BAYSIDE COUNCIL

Planning Assessment Report

Application Number:	DA-2016/276
Date of Receipt:	11 February 2016
Property:	4 Innesdale Road, WOLLI CREEK NSW 2205 Lot 15 DP 4032
Owner:	VP1 Pty Ltd
Applicant:	VP1 Pty Ltd
Proposal:	Construction of a six (6) storey boarding house, comprising 38 boarding rooms including one manager's room, rooftop communal open space and ground level parking and demolition of existing structures
Recommendation:	Approved
No. of submissions:	Eight (8) including one (1) petition with 46 signatures, 4 submissions from one household and three individual letters.
Author:	Fiona Prodromou
Date of Report:	22 September 2016

Figure 4 - Proposed height variation

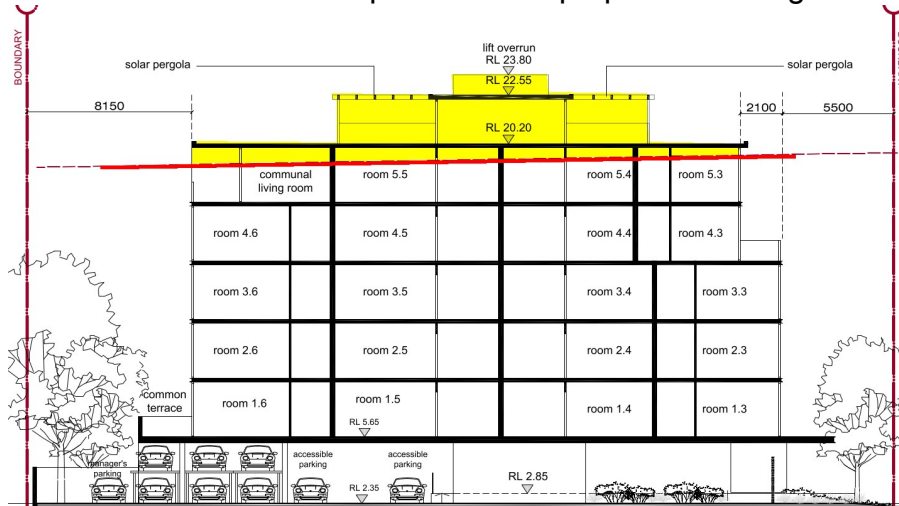
As noted within Clause 4.3 - Height of Buildings, the proposal incorporates a proposed height variation of 6.8% to 27% to a small portion of the proposed building on site.

- The subject site is constrained as a result of a flooding affectation. Accordingly the ground level of the development is required to be raised 1.35m in order to provide minimum habitable floor levels which will be above the flood level for the site. The flooding affectation is directly correlated to the additional height proposed in this instance. It is noted that in the event that the site was not subject to a flooding constraint the proposed development to the roof level would comply with the height limit for the site.
- The proposed rooftop structures are directly correlated to the design, function and intended use of the rooftop communal open space area which forms an integral part of the proposed development. The structures service the rooftop communal open space area which has been

- The rooftop communal terrace is recessed into the site with planting proposed forward of the southern extent, comprising shrubs and groundcovers with a mature height of 1.5m. The proposed landscaping will assist in softening the appearance and extent of rooftop structures which exceed the height limit.

Given the site and development circumstances as discussed above, the proposed additional height sought by the applicant in this instance is not considered to be unreasonable. Given the above, the proposal provides for a development that facilitates the orderly economic development of the site in an appropriate manner. The particular circumstances of the site are considered to outweigh strict adherence to the numeric standards presented by the Height standard within RLEP 2011. It is considered that in this instance, there are sufficient environmental planning grounds and site circumstances in which to justify the contravention of the height standard for the site.

Figure 5 - Shadow Diagrams, 9am, 10am, 11am midwinter.

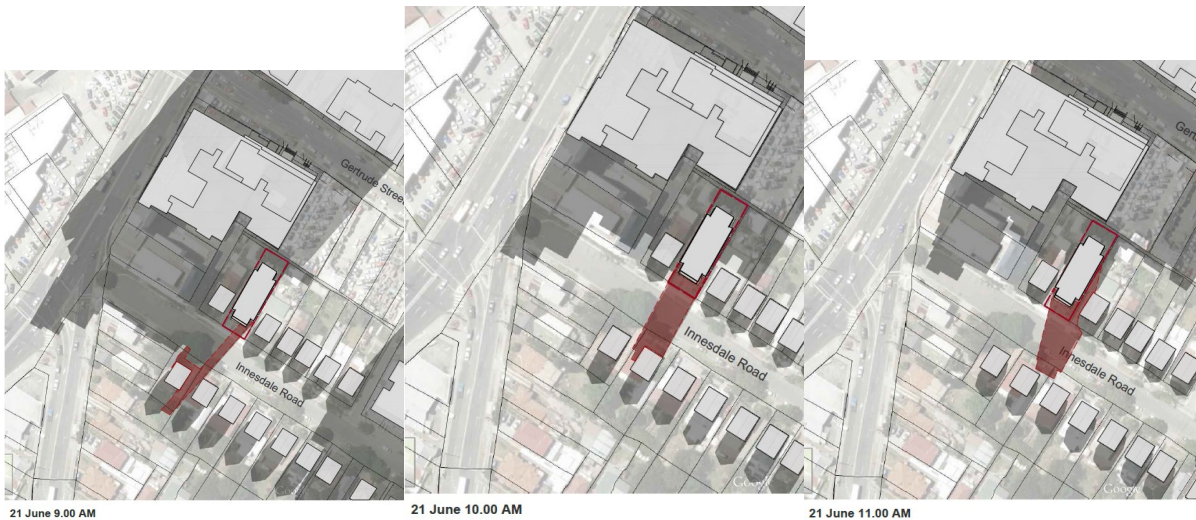
Shadow diagrams indicate that the proposal will result in minor additional overshadowing to portions of the front yard, northern and eastern elevation of the properties at 1A, 1 and 3 Innesdale Road between the hours of 9am - 10am. Notwithstanding, at 11am, the shadow cast by the development does not impact upon the dwellings and is purely within the front yard of the aforementioned sites.

At 12pm this shadow recedes and the properties on the southern side of Innesdale Road benefit from complete solar access for the remainder of the day. The proposal complies with the provisions of this clause.
